**City of Portland, Oregon - Bureau of Development Services**

**Type II and IIX Decision Appeal Form** LU Number: 22-159396 AD**FOR INTAKE, STAFF USE ONLY**

PROPOSAL SITE ADDRESS 2788 28th Ave DEADLINE OF APPEAL 3/17/2023

## Attachment "A" Appeal of Adjustments at 2788 NW Thurman St

LU 22-159396 AD  
Exh. C.2  
ZONING ADJUSTMENT 1  
BUILDING HEIGHT REDUCED TO 28'-0"  
A SECOND FLOOR BALCONY & SIGN

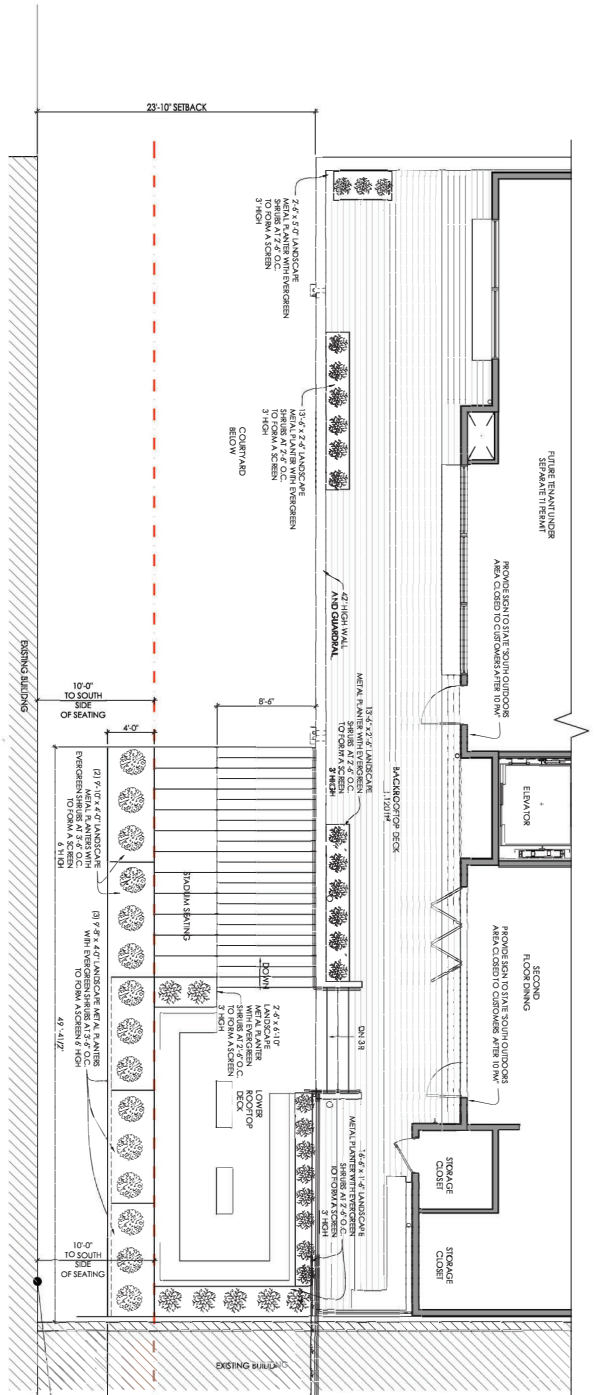
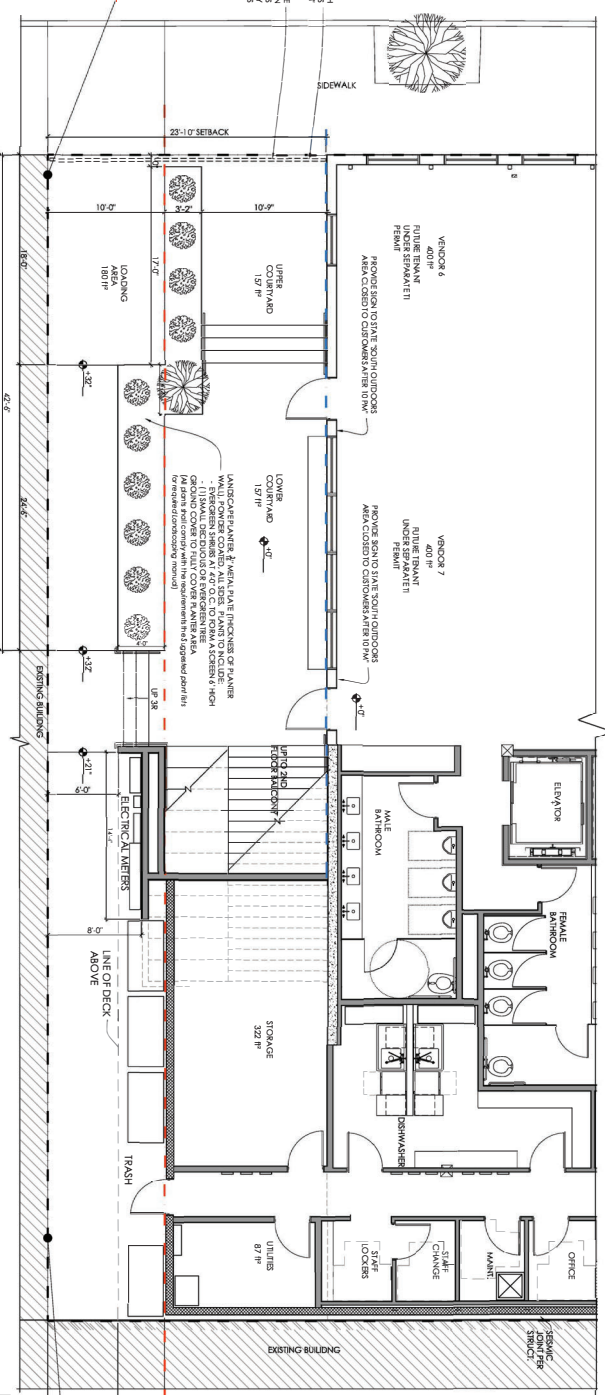
- **The above description mischaracterizes the configuration of the Trolleycar Lofts. In addition to the roof decks on the Loft building there are sleeping areas in each of the 6 units abutting these decks, and while the wall on the property line is solid, these upper level bedrooms have required operational skylights and windows and doors opening to the decks on this level. As noted above, these rooms and decks will be severely compromised by the proposed configuration of the project. As noted by the planner, the southeastern section of the addition, where outdoor seating is shown, is proposed to be within 6 feet of the existing residences to the south. The location of the outdoor seating within 6 feet is NOT EQUAL TO OR BETTER for the adjacent homeowners than the required setback.**

- **The proposed addition is not described other than in volumes. Neither complete floor plans, materials or details are included in the submittal, so it is unclear whether the design is appropriate on the context of the site, the neighborhood or whether it will integrate aesthetically with the existing building.**

In response to the assertion that approving the Adjustment request will allow a roof patio and seating within the setback, staff notes that the applicant submitted a revised plan set which increased the width of the landscape planter areas along the southernmost seating areas (lower courtyard, stadium seating, and lower rooftop deck) to 4 feet to allow for additional landscape buffer area and to eliminate customer seating areas within the minimum 10-foot building setback for abutting residential lots. (Exhibit C.2).

- B. The landscaped buffer areas along the southern edge of the seating areas (upper courtyard, lower courtyard, stadium seating, and lower rooftop deck, as shown on Exhibit C.2) must be continuously maintained in a healthy manner. Plants that die must be replaced in kind.
